Plan Commission

Monday, August 22, 2022

SUBJECT: Consideration and possible action on an amended Precise Implementation Plan for a proposed drive-in or convenience food establishment at 1610 Lawrence DR (Parcel WD-D0015-2-1). *

- ITEM 5:** Consideration and possible action on an amended Precise Implementation Plan for a proposed drive-in or convenience food establishment at 1610 Lawrence DR (Parcel WD-D0015-2-1). *

LANDSCAPE PLAN

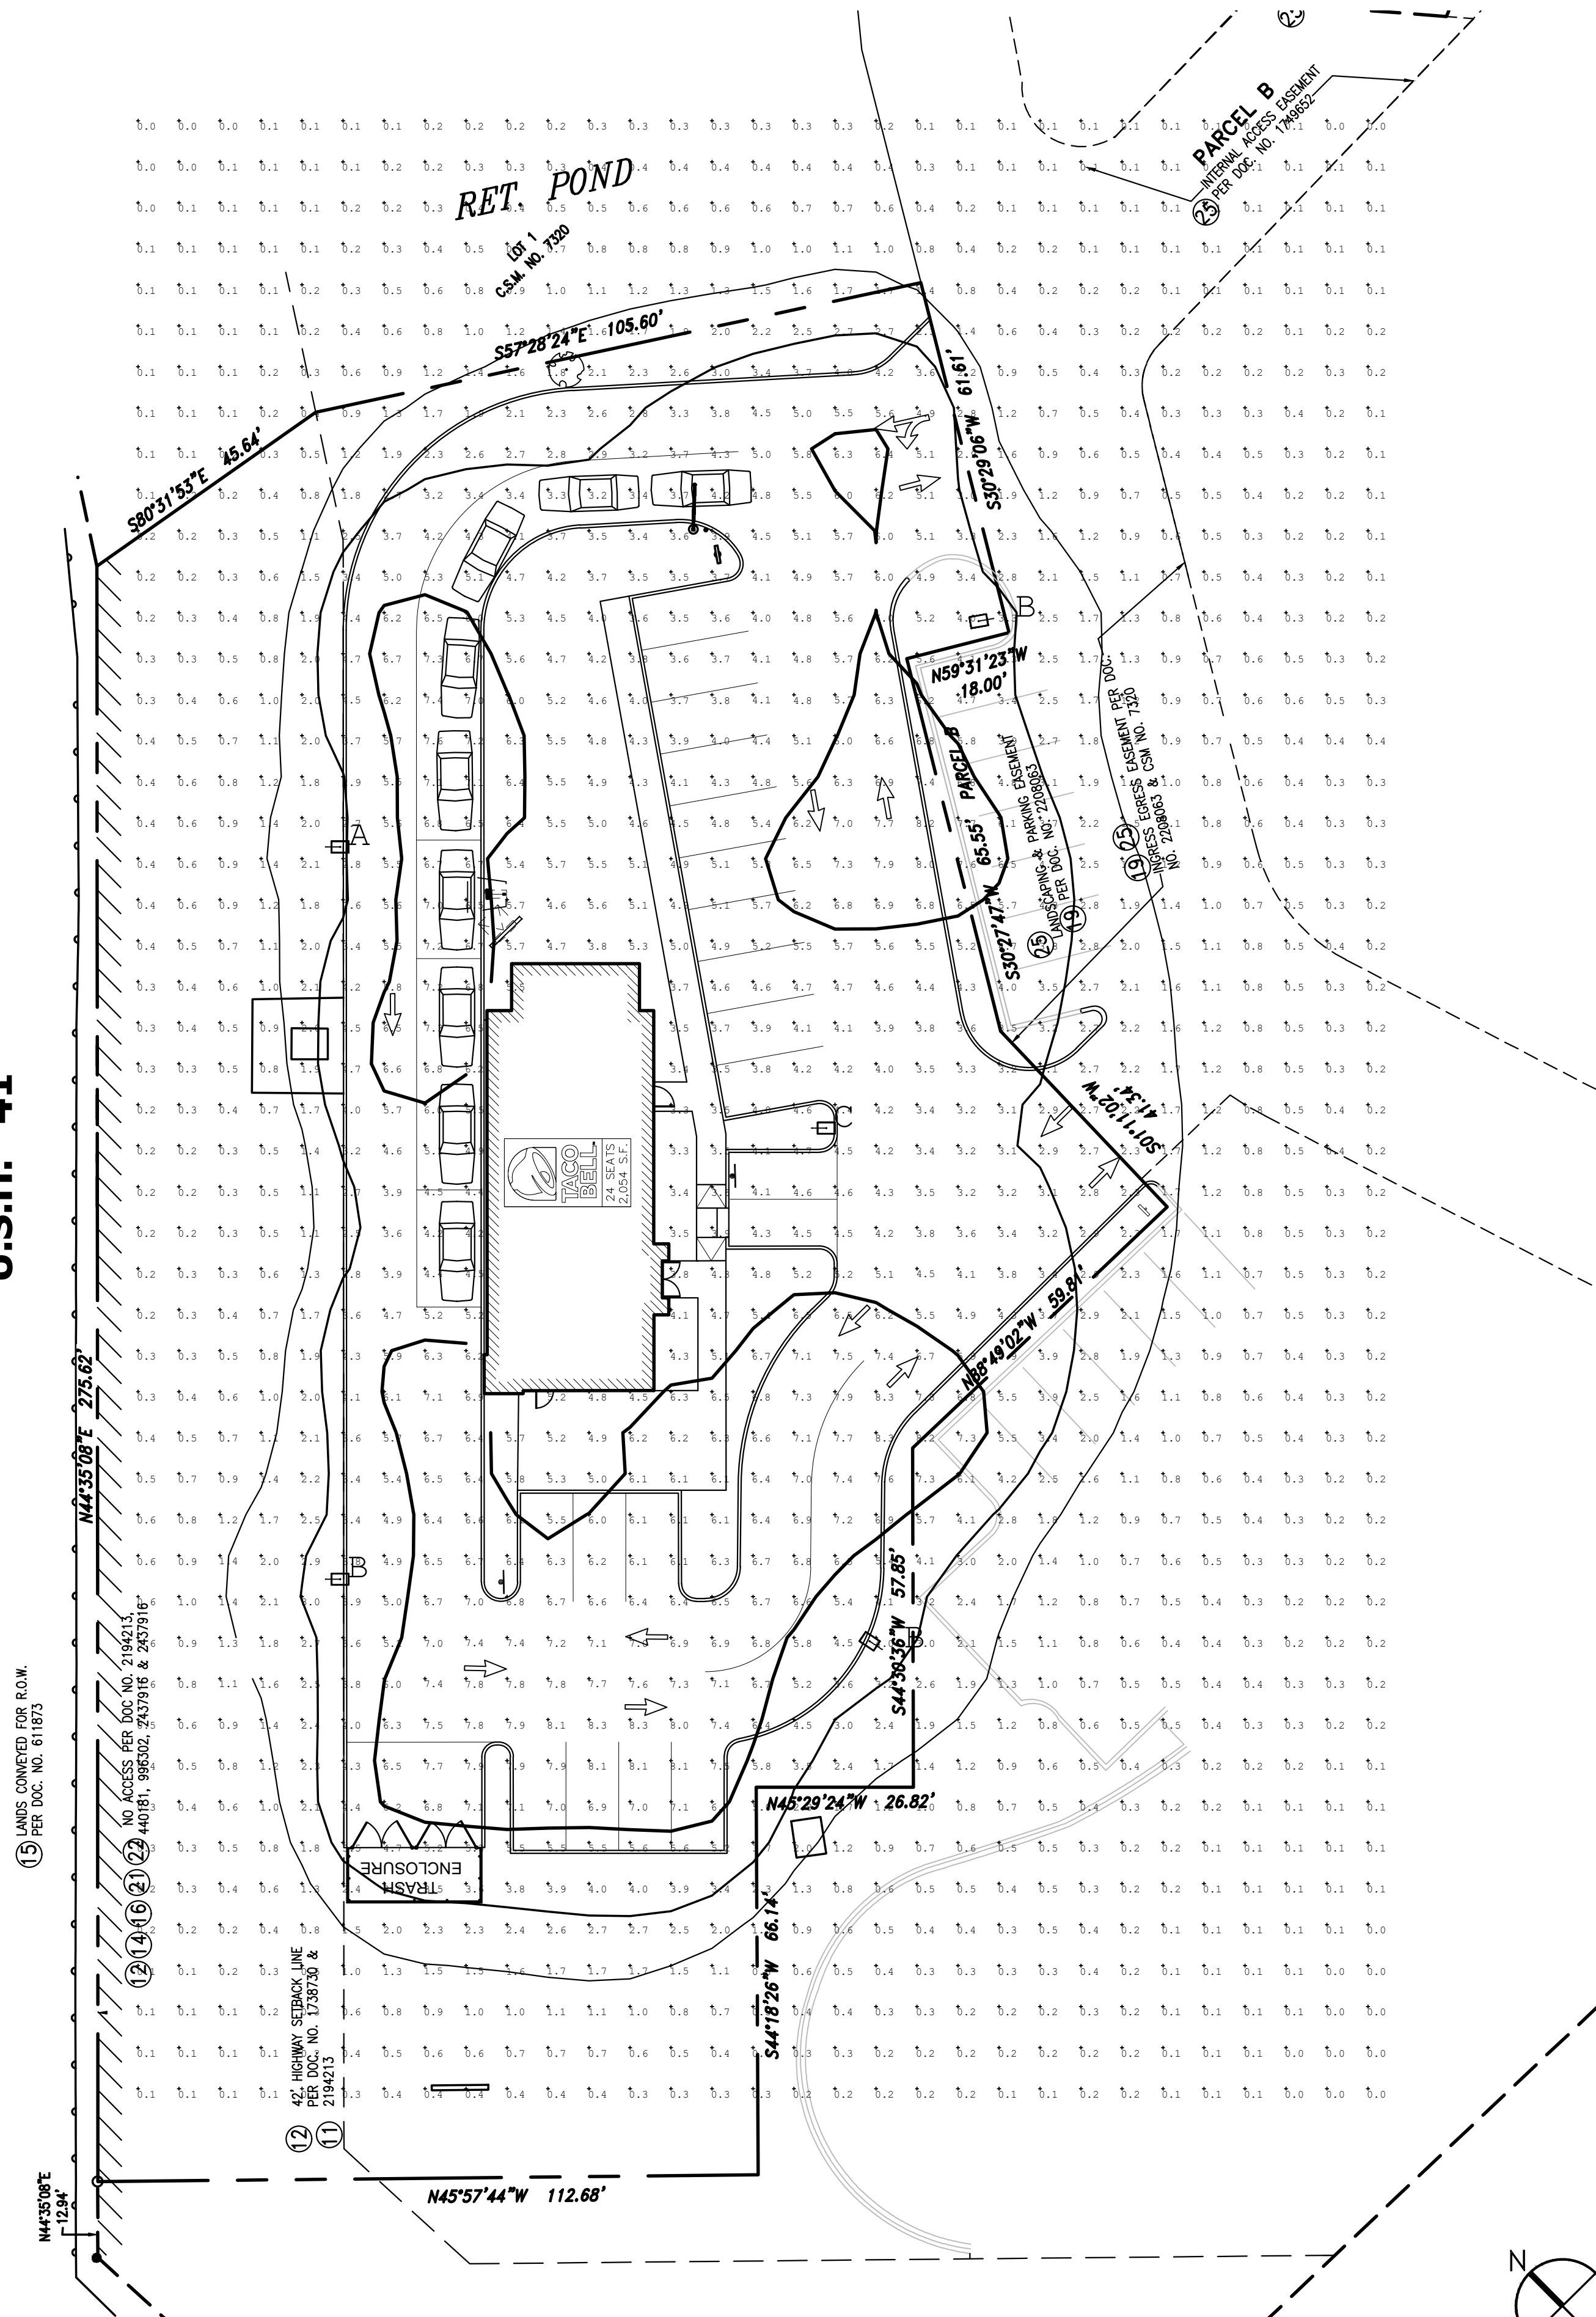
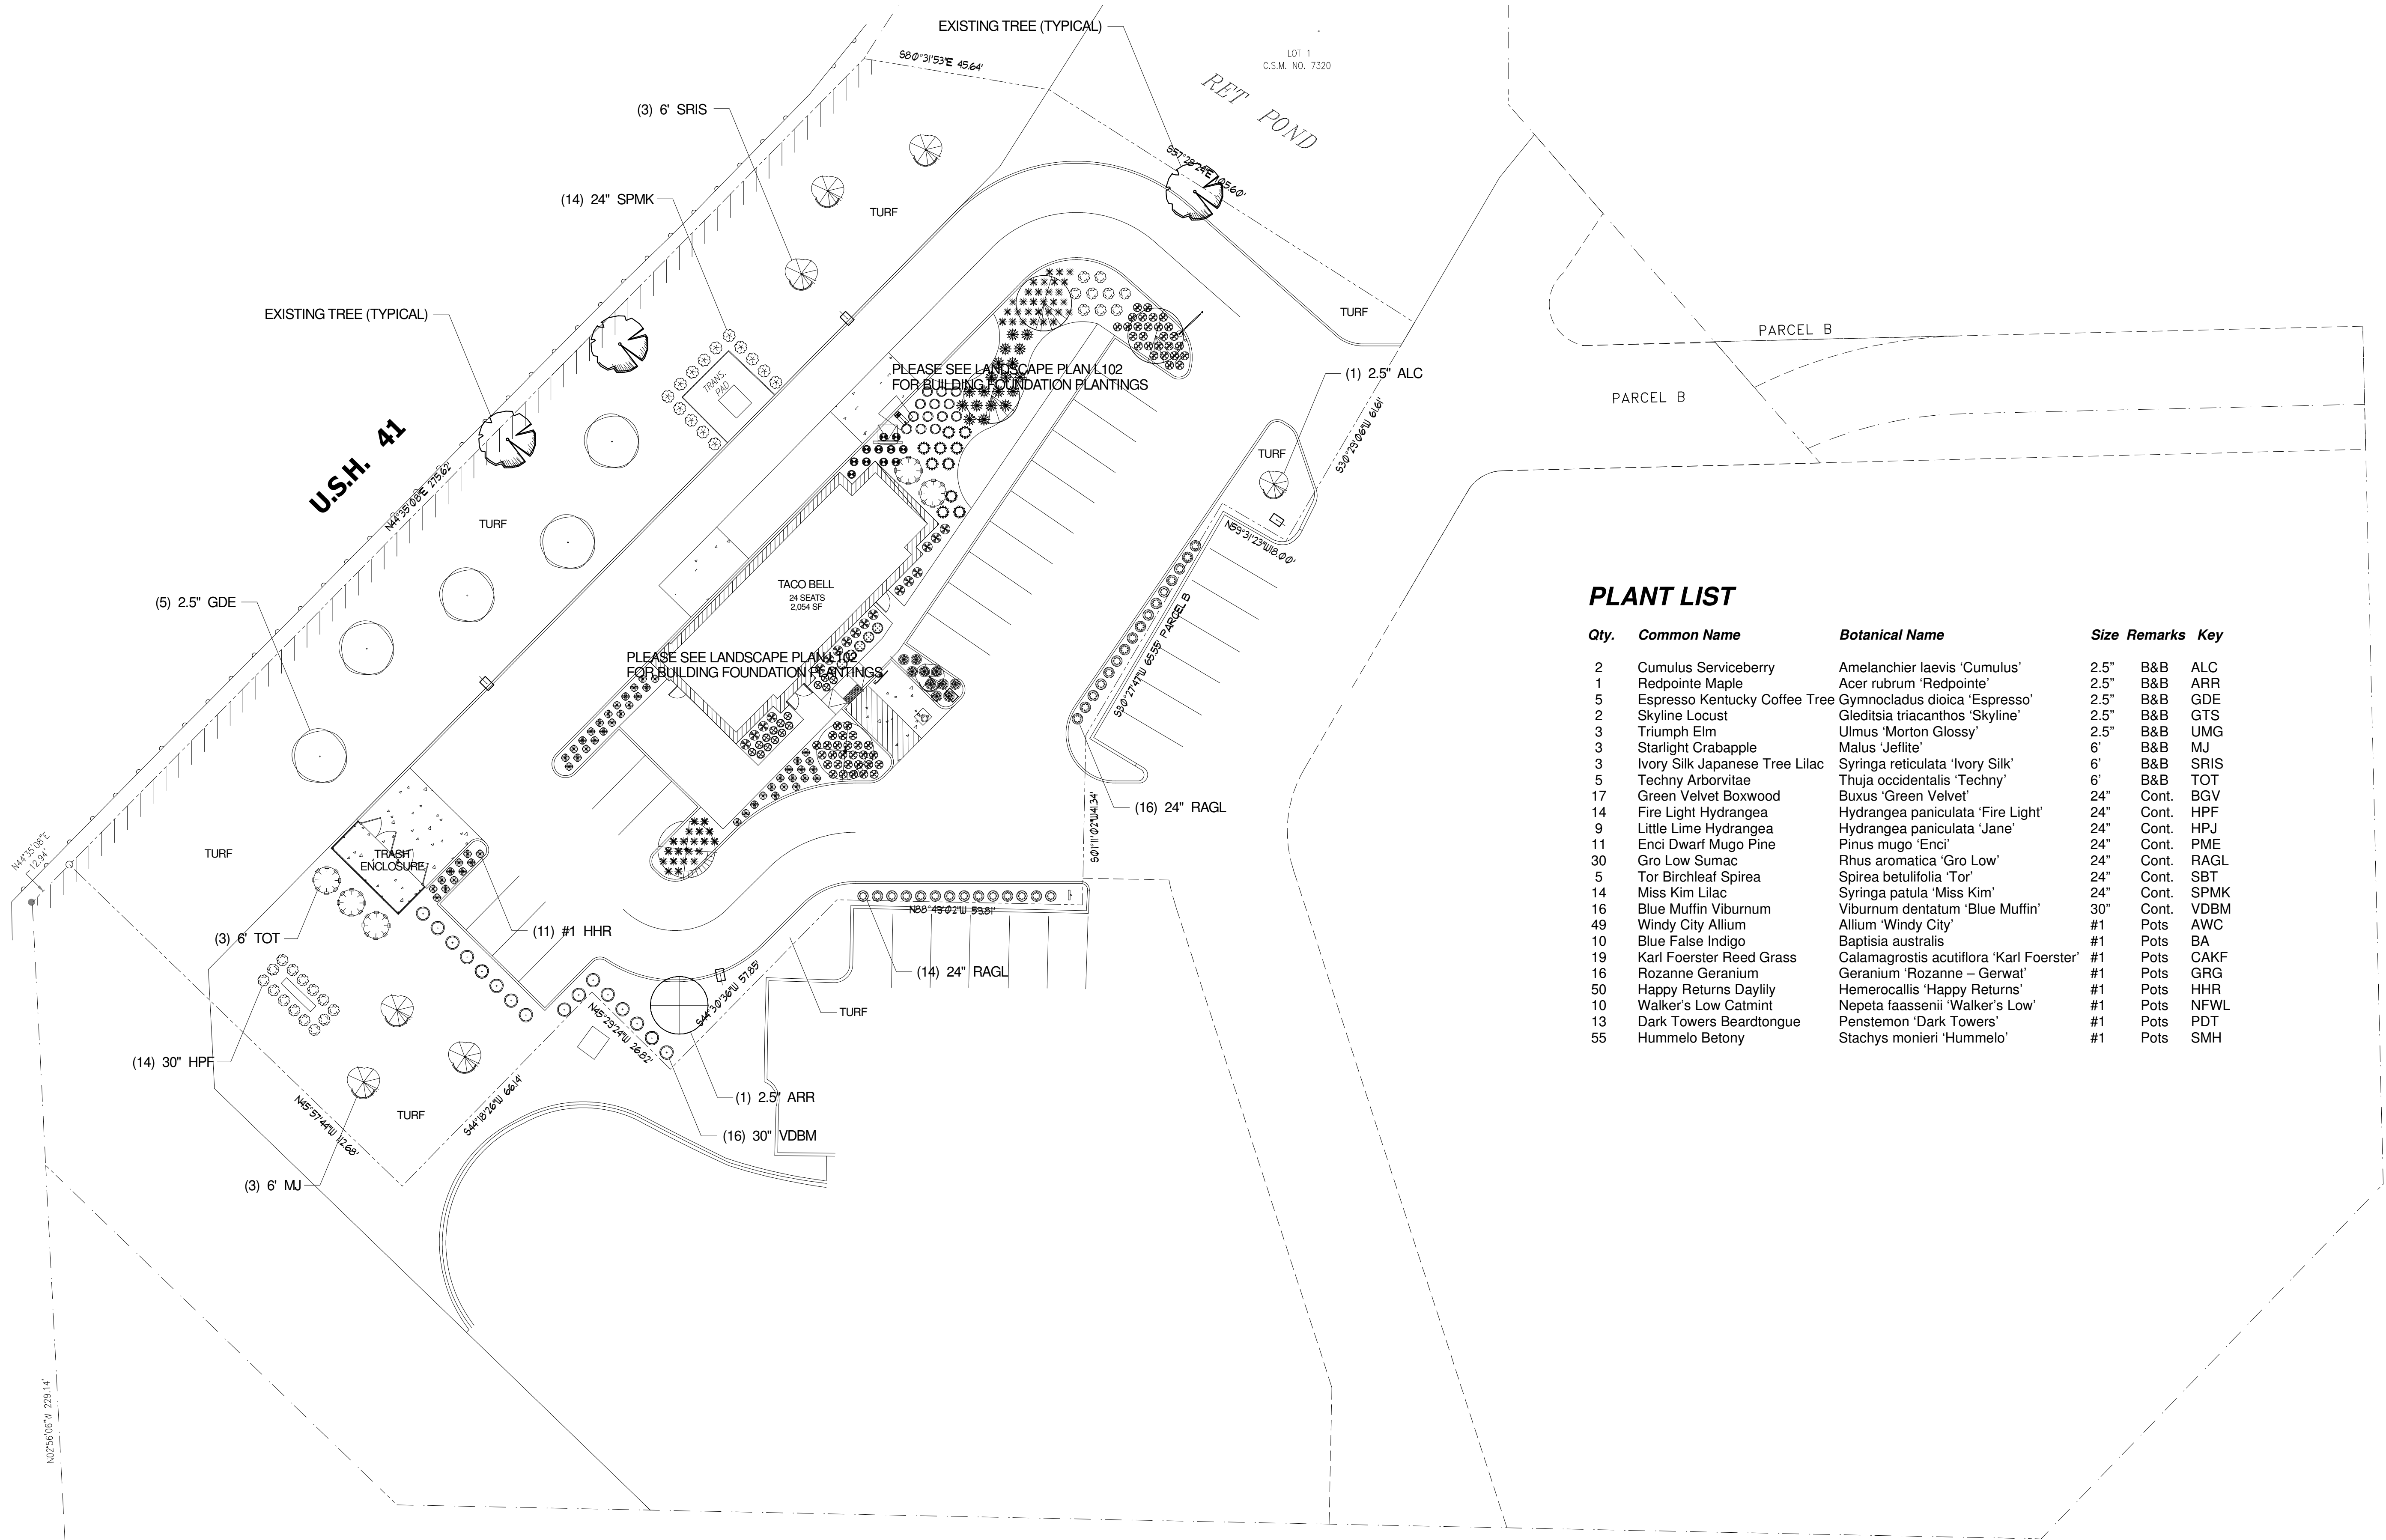
The developer included a robust Landscape Plan. In particular, staff asked for trees to be added along the freeway to beautify the property; 8 trees are proposed to be added to the two existing trees on the west side of the building. There are additional trees and landscaping features on the other sides of the building.

- 5. Clarify that landscaping has been placed between the walkway and the building on the east side. Landscaping is visible in the Landscape Plan but it is not visible in the color renderings.

SCALE:
PROJECT NO. 22027
DATE: 7/29/2022
SHEET NUMBER
CE-1

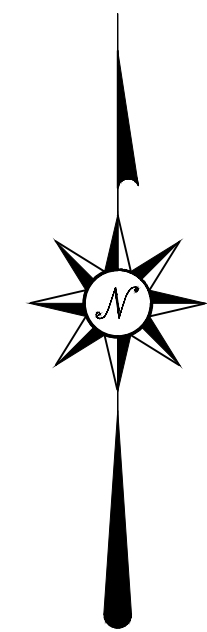
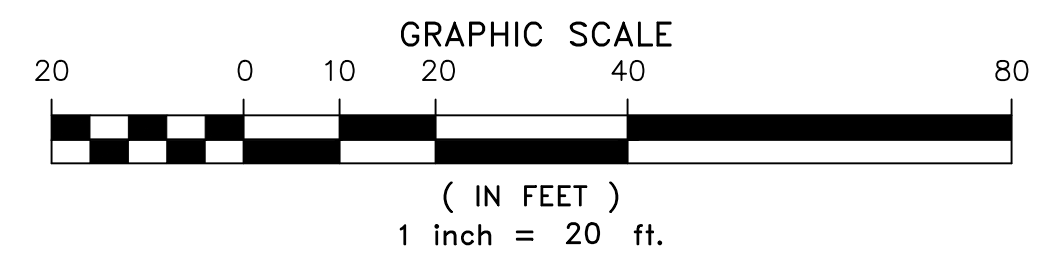
1. Sheet CE-1 Comments.
 - a. Provide developer name and street address.
 - b. Provide site address.
 - c. In the plan index, the specifications and details are on sheet CE-6 and CE-7.
